Carlisle High School Parking Expansion (North) – Site Plan

City of Carlisle, Iowa
FOX P.N. 8666-18B.241

FOX Engineering & City Staff have completed the second review for the Carlisle High School Parking Expansion Site Plan submittal dated July 20, 2021 and offer the following comments:

RE: **840 School Street – Site Plan Review**
Carlisle, Iowa
FOX Ref No: 8666-21C.240

Sheet C3.0 – Dimension Plan:

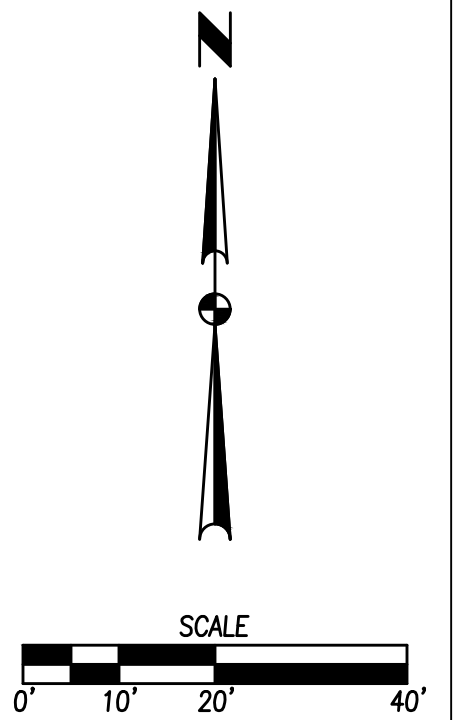
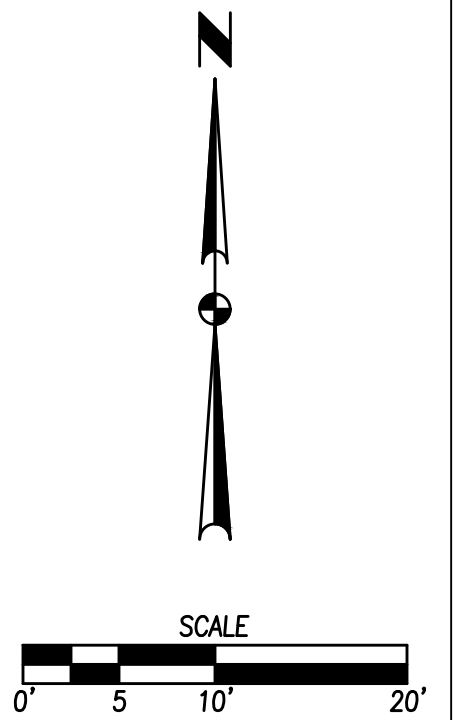
2. A waiver is required to place the parking lot within 10-ft of the residential property (See 165.06, 5, F, 2). Please submit a formal waiver request letter to the City prior to the meeting on Monday.

Sheet C4.1 – Grading Plan:

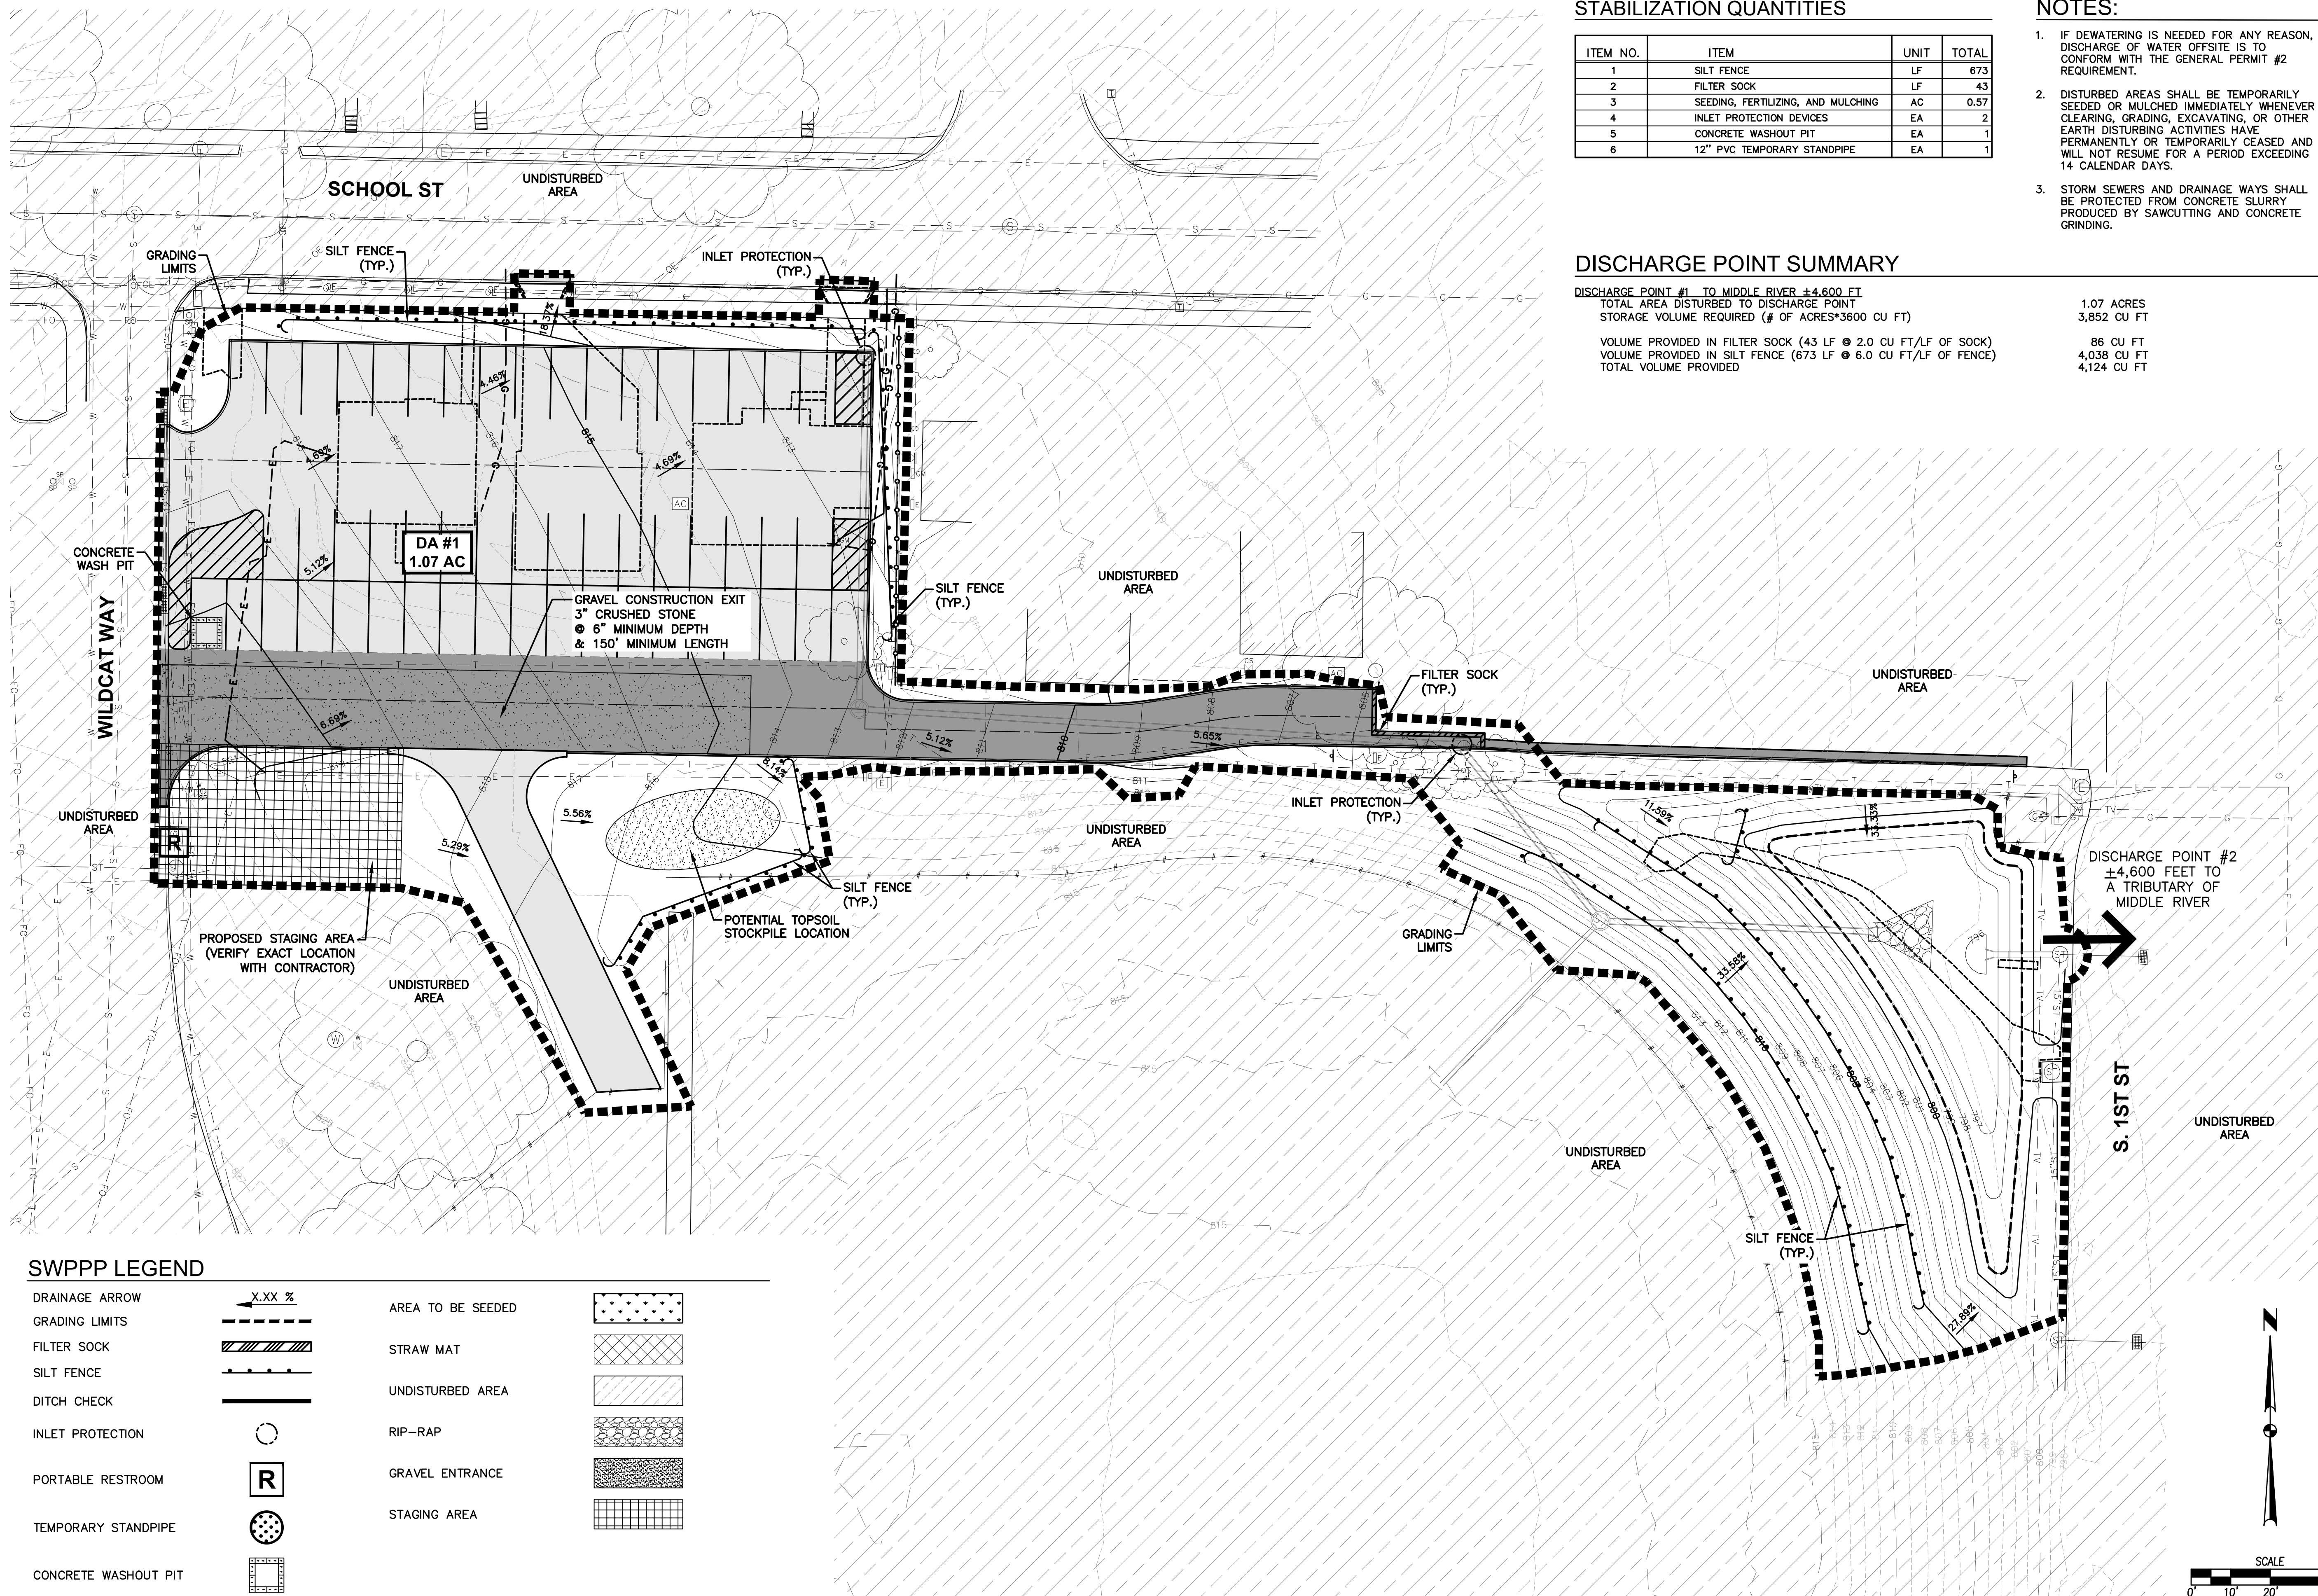
3. There is grading shown on the Bradley/Carmel Petersen property beyond the ingress/egress easement shown. Please show a temporary easement and/or clarify that permission is granted for this work.

Sheet C2.1 – Layout Plan:

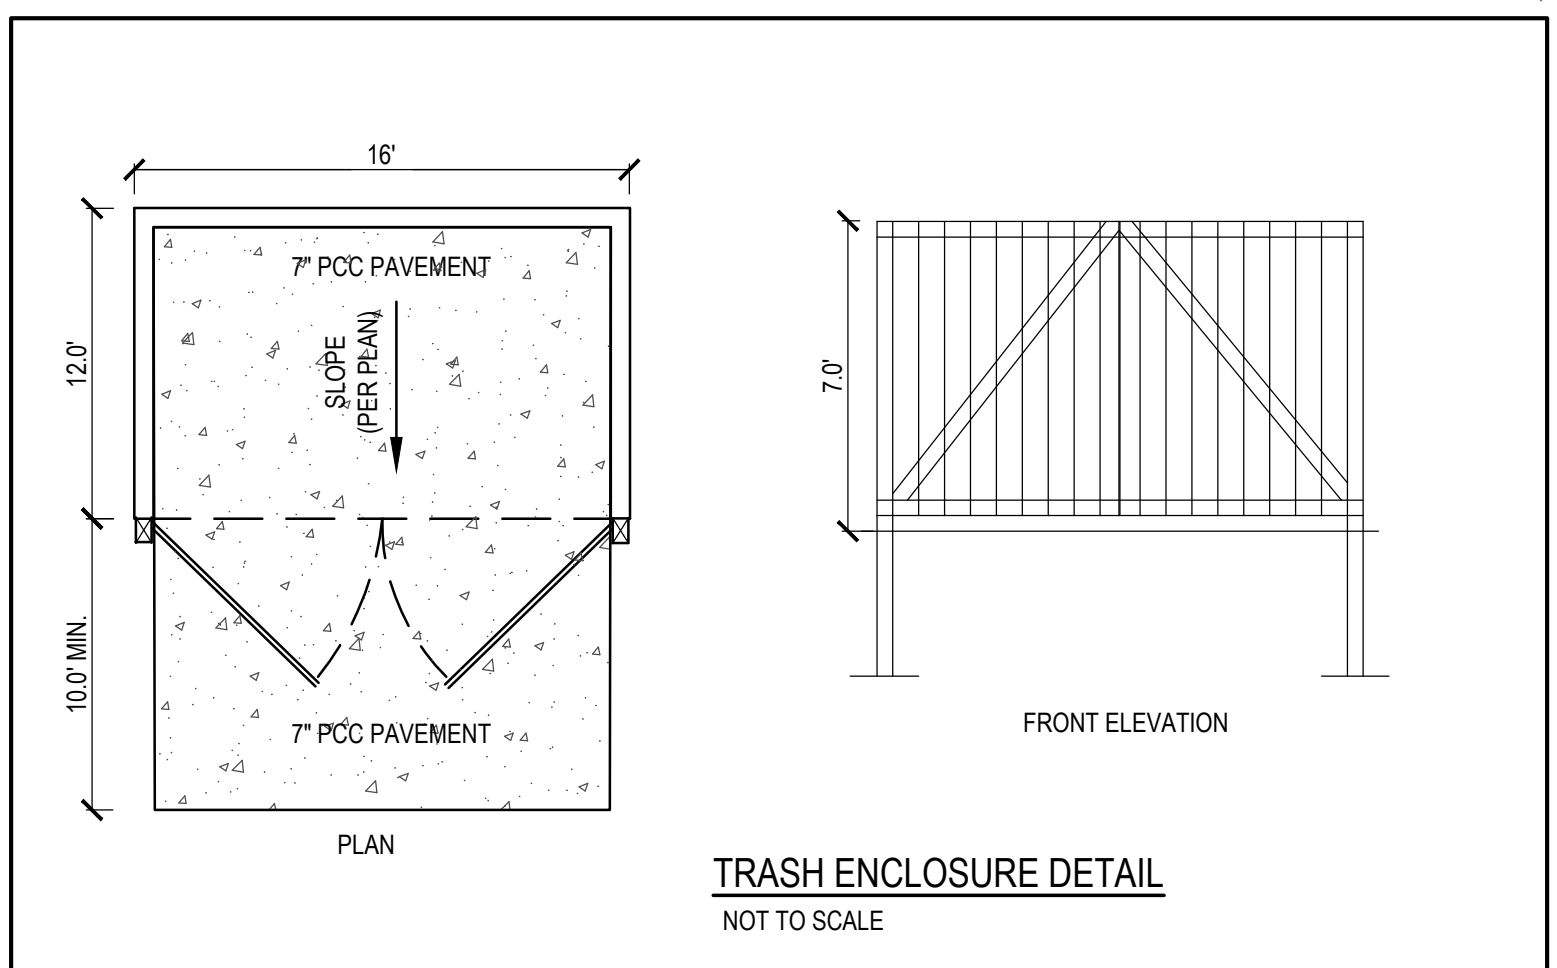
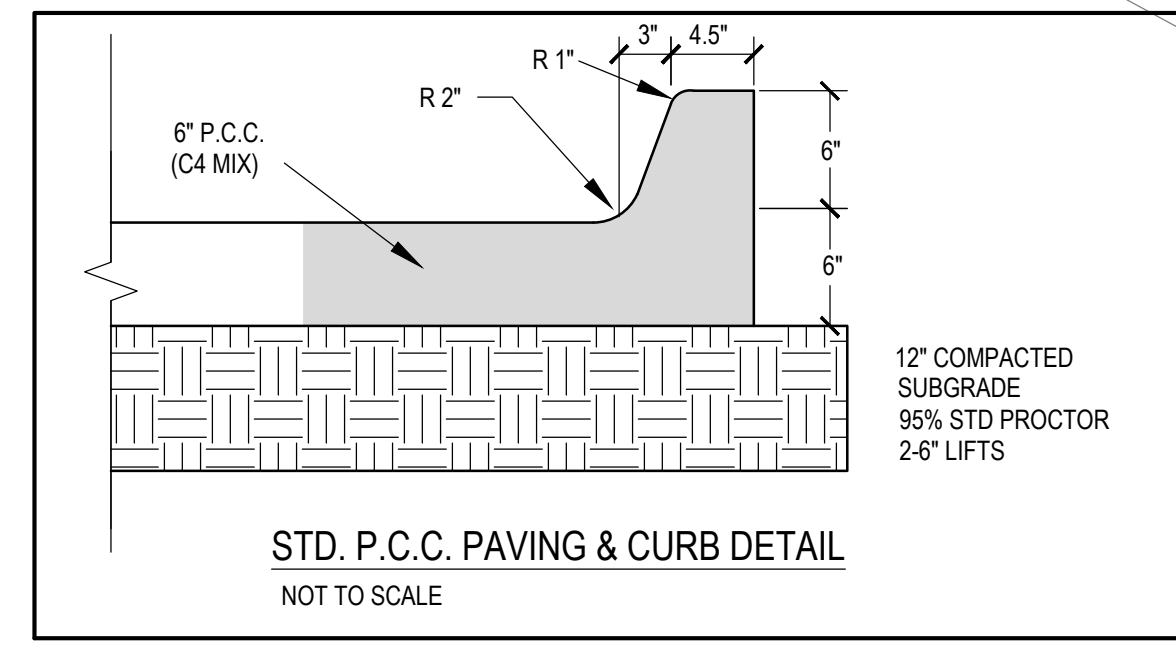
6. Please provide additional labels/information on the dumpster enclosure detail to verify that trash screening is of similar building material as the primary building.

7. Per 165.12, 3, B, 5: Roof-mounted mechanical, communications, or other similar equipment shall be screened from public view by the use of parapet walls or other roof structures. If a parapet wall or other roof structure cannot feasibly screen the roof mounted equipment, point-in-place or other appropriate screening with similar design features to the building, including material, shape, and color shall be required. It is difficult to understand whether the A/C units will be visible from Highway 5. Please clarify and/or provide assurance that the mechanical units will not be seen from public right of way to the south of the site.
